# Access Compliance Report

## Public Rights-of-Way

### (Curb Ramps)

Intersection ID: 10023633	Main Street: CLOSEBURN_RD	Cross Street: N/A	Location: S
ADA ID: 0051BB53056E	Ramp Type: ParaDiag	Initial Pass/Fail: Fail	Overall Compliance: No
		Severity Score: 25

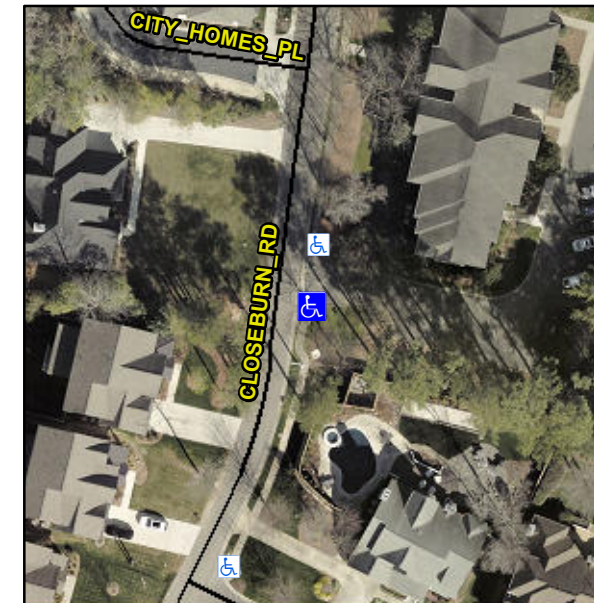
**RT RP < 5%**

**R304.3.2**

Compliance	Description	Data	Compliance	Description	Data
N/A	Ramp Length LT (in)	32.0	N/A	Ramp Length RT (in)	51.0
Yes	Ramp Width LT (in)	60.0	Yes	Ramp Width RT (in)	61.0
No	Ramp Slope LT (%)	12.1	Yes	Ramp Slope RT (%)	1.5
Yes	Ramp XSlope LT (%)	0.5	Yes	Ramp XSlope RT (%)	0.7
N/A	Landing Length (in)	N/A	N/A	DWS Provided?	N/A
N/A	Landing Width (in)	N/A	N/A	DWS Contrast?	N/A
N/A	Landing Slope (%)	N/A	N/A	DWS Length (in)	N/A
N/A	Landing X Slope (%)	N/A	N/A	DWS Full Width?	N/A
N/A	Landing Curb? (Y/N)	N/A	N/A	DWS Offset (in)	N/A
N/A	Shared Landing?	N/A			
N/A	Gutter Ponding?	N/A	N/A	Gutter Slope (%)	N/A
N/A	Gutter Lip Ht (in)	N/A	N/A	Gutter X Slope (%)	N/A
N/A	Painted X Walk1?	No	N/A	Painted X Walk2?	No
	X Walk 1 Direction	To N		X Walk 2 Direction	To W
N/A	X Walk 1 Width (in)	N/A	N/A	X Walk 2 Width (in)	N/A
	X Walk 1 Slope (%)	0.5		X Walk 2 Slope (%)	2.1
	X Walk 1 X Slope (%)	3.5		X Walk 2 X Slope (%)	1.2
N/A	Ramp inside XWalk1?	N/A	N/A	Ramp inside XWalk2?	N/A

**Remove & Replace Curb Ramp With Two New Directional Ramps or Equivalent.**
